**DEPARTMENT OF TRANSPORTATION**

Contract #: 04-0120F4Cty: SF/ALA Rte: 80 PM: 13.2/13.9File #: 69.28**WELDING INSPECTION REPORT****Resident Engineer:** Siegenthaler, Peter**Address:** 333 Burma Road**City:** Oakland, CA 94607**Report No:** WIR-016944**Date Inspected:** 03-Sep-2010**Project Name:** SAS Superstructure**OSM Arrival Time:** 700**Prime Contractor:** American Bridge/Fluor Enterprises, a JV**OSM Departure Time:** 1900**Contractor:** Zhenhua Port Machinery Company, Ltd (ZPMC), Changxing Island **Location:** Shanghai, China**CWI Name:** Zhao Chen Sun**CWI Present:** Yes No**Inspected CWI report:** Yes No N/A**Rod Oven in Use:** Yes No N/A**Electrode to specification:** Yes No N/A**Weld Procedures Followed:** Yes No N/A**Qualified Welders:** Yes No N/A**Verified Joint Fit-up:** Yes No N/A**Approved Drawings:** Yes No N/A**Approved WPS:** Yes No N/A**Delayed / Cancelled:** Yes No N/A**Bridge No:** 34-0006**Component:** Tower Components**Summary of Items Observed:**

**LIFT-3 TOWER CROSS BRACING GUSSET PLATE AT 89 M ELEVATION****WD1 – GUSA3 – 3 – 89M – S – 3A/B; 4A/B****WD1 – GUSA3 – 3 – 89M – N – 3A/B; 4A/B**

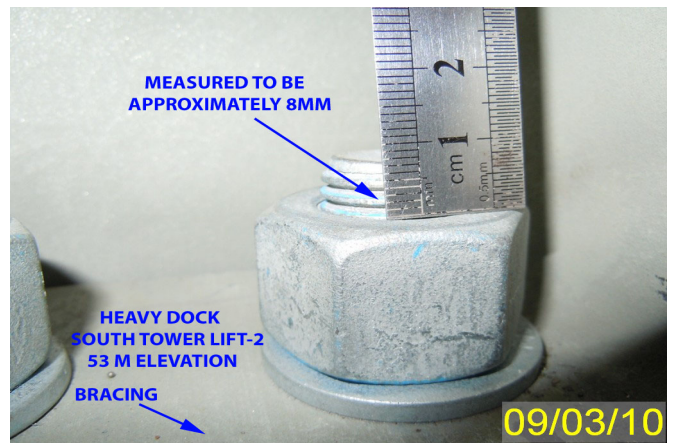
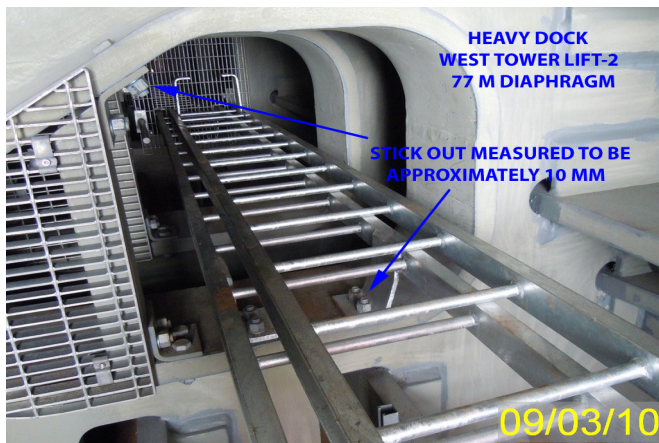
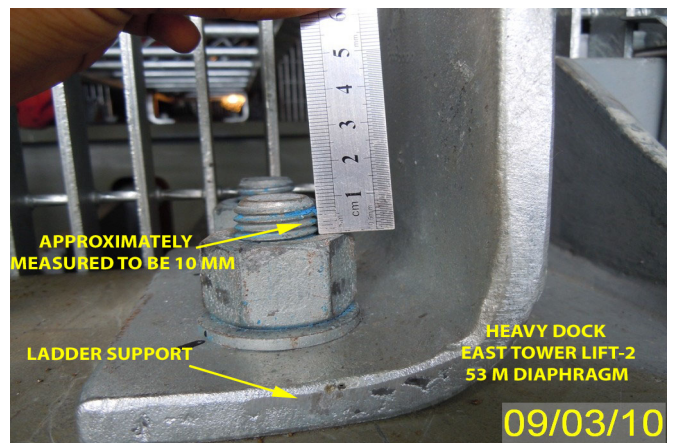
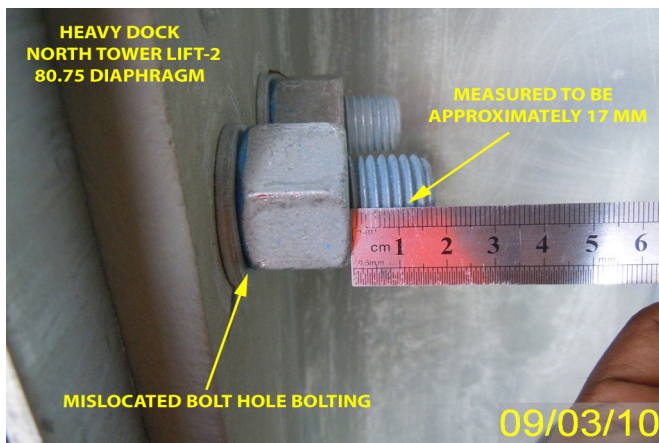
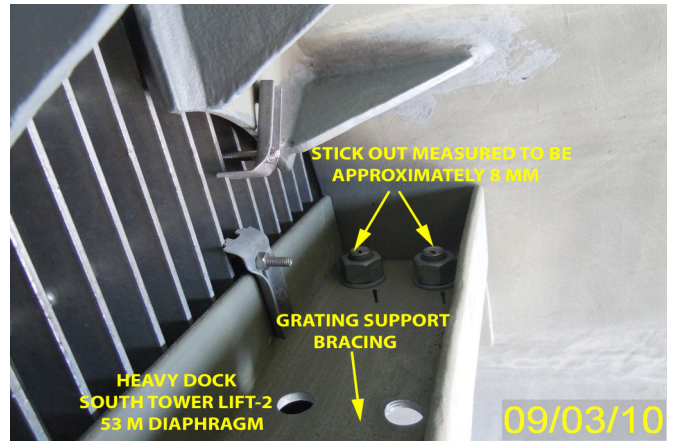
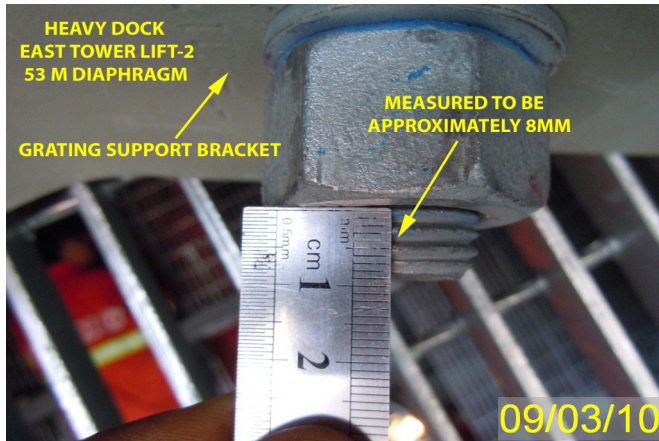
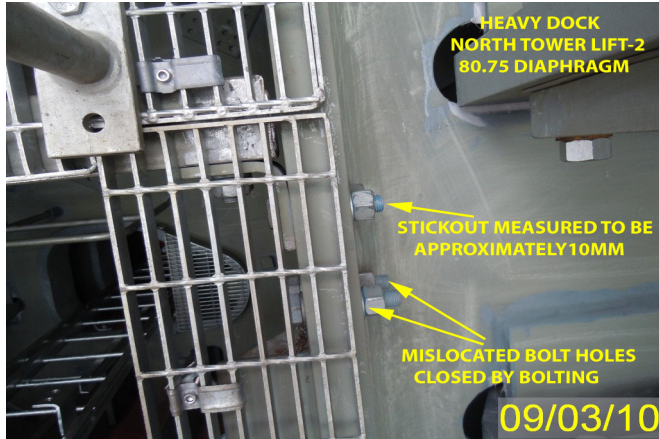
During random bolting survey verification in North, West, South & East Shafts of Lift 2, this Caltrans Quality Assurance (QA) Inspector discovered the following issues:

- Nearly most of the bolting in North, West, South and East shafts of lift-2 of grating support brackets, bracings and ladder support brackets, thread stickout measured to be beyond 6mm. This is not compliance with the Caltrans standard specifications.
- Approximately the measured lengths of the thread stickout ranges are from 8 to 10 mm.
- And for four (4) mislocated bolt holes on south and four (4) on north shafts at 80.75 M diaphragm's were closed by bolting. For these boltings thread stickout measured to be more than 15 mm.
- These Tower shafts are located on the ship.

SECTION 55; 55-3.14B Installation

“For all bolts, the threaded end projecting past the outer face of the nut (thread stickout), where first full formed thread is present, shall be at least flush with, but not more than 6 mm beyond, the outer face of the nut.”
